# Access Compliance Report

## Public Rights-of-Way

Intersection ID: 6194	Main Street: LIATRIS_LN	Cross Street: VALERIAN_CT	Location: W
ADA ID: B72A7357BE86	Ramp Type: Perp	Initial Pass/Fail: Fail	Overall Compliance: No
Severity Score: 46.25			
Codes/Mitigation Info/Possible Solution		Field Measurements/Component Compliance

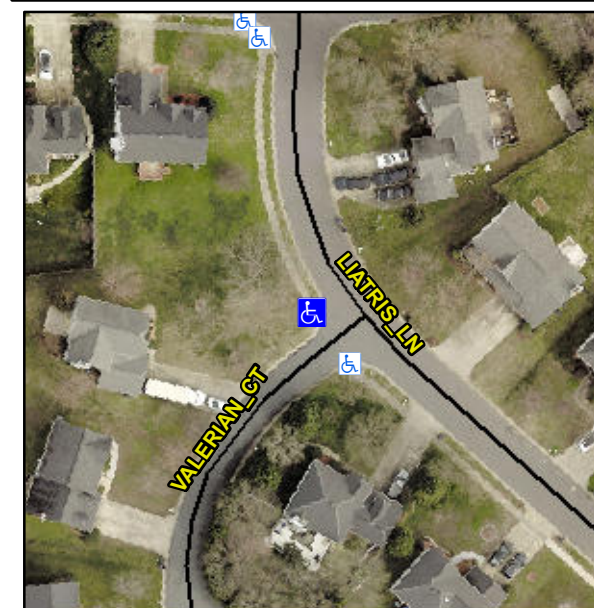
**Not Found, R304.5.1, R304.2.2, R304.5.3**

Compliance	Description	Data	Compliance	Description	Data
N/A	Ramp Length (in)	49.0	No	Ramp Slope (%)	12.1
No	Ramp Width (in)	46.0	No	Ramp XSlope (%)	5.6
N/A	Flare Type LT	N/A	N/A	Flare Type RT	N/A
N/A	Flare Slope LT (%)	N/A	N/A	Flare Slope RT (%)	N/A
N/A	Flare Traversable LT?	N/A	N/A	Flare Traversable RT?	N/A
N/A	Landing Length (in)	N/A	N/A	DWS Provided?	N/A
N/A	Landing Width (in)	N/A	N/A	DWS Contrast?	N/A
N/A	Landing Slope (%)	N/A	N/A	DWS Length (in)	N/A
N/A	Landing X Slope (%)	N/A	N/A	DWS Full Width?	N/A
N/A	Landing Curb? (Y/N)	N/A	N/A	DWS Offset (in)	N/A
N/A	Shared Landing?	N/A			
N/A	Gutter Ponding?	N/A	N/A	Gutter Slope (%)	N/A
N/A	Gutter Lip Ht (in)	N/A	N/A	Gutter X Slope (%)	N/A
N/A	Painted X Walk1?	No	N/A	Painted X Walk2?	N/A
	X Walk 1 Direction	To SE		X Walk 2 Direction	N/A
N/A	X Walk 1 Width (in)	N/A	N/A	X Walk 2 Width (in)	N/A
	X Walk 1 Slope (%)	2.7		X Walk 2 Slope (%)	N/A
	X Walk 1 X Slope (%)	4.3		X Walk 2 X Slope (%)	N/A

**Remove & Replace Entire Ramp.**
